STATE OF MAINE
DEPARTMENT OF TRANSPORTATION
16 STATE HOUSE STATION
AUGUSTA, MAINE
04333-0016

May 13, 2003
Subject: Palmyra, Newport, Plymouth, Etna, and
Carmel
Project No. IM-95-1211(800)E
PIN 12118.00
Bid Amendment No. 1

WIDEN SHLD.1
1/24/03

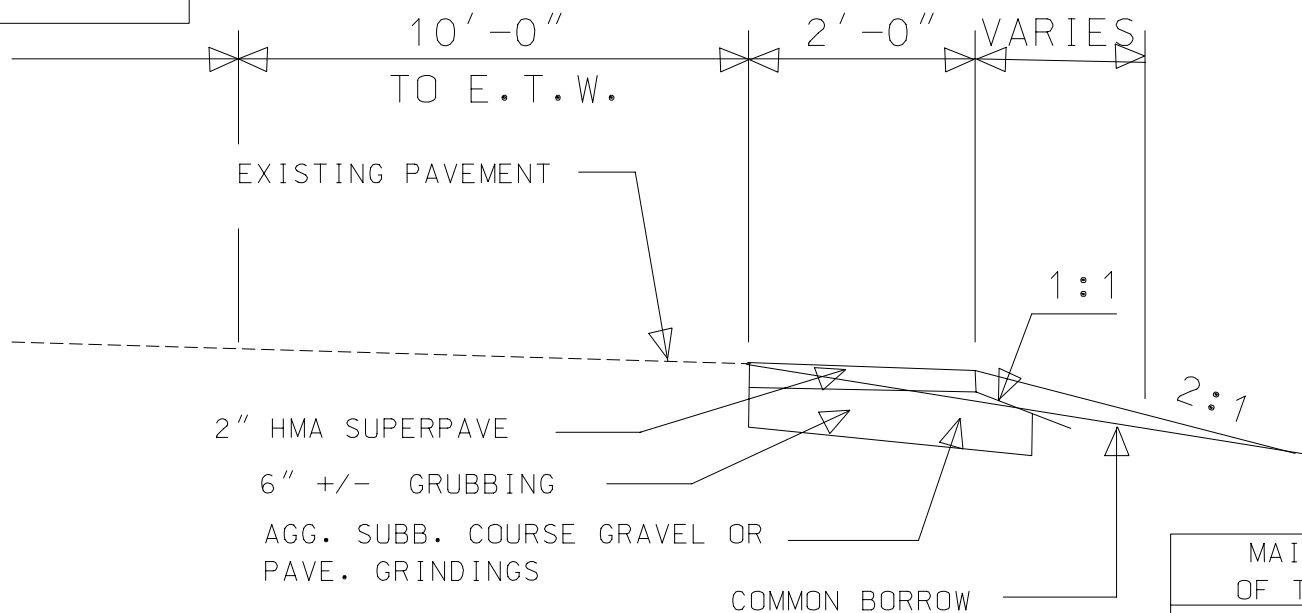
- 1) Add the attached two pages dated March 4, 2003 entitled Special Provision "401 Hot Mix Asphalt Centerline Joint Density."
- 2) Add the attached two pages dated 1/24/03 entitled "Interstate Shoulder Widening I-95."
- 3) Please add the following to the General Notes.
 - a) Cleaning of the pavement following rental work will be considered incidental to the rental items. Cleaning will be done daily and to the satisfaction of the Resident prior to the Contractor leaving the Project for the day.
- 4) Please add the following to the Construction Notes.
 - a) Under item 606.1721 Bridge transition type 1, only two granite transition curbs are required at the station 2983 +12 Rt. and 2982+96 Lt.

10'-0" TO 12'-0"

THE SLOPE AT THE TIP
OF THE GUARDRAIL
WIDENING SHALL BE 3:1

USED WITH EXISTING PAVEMENT ON SHOULDER
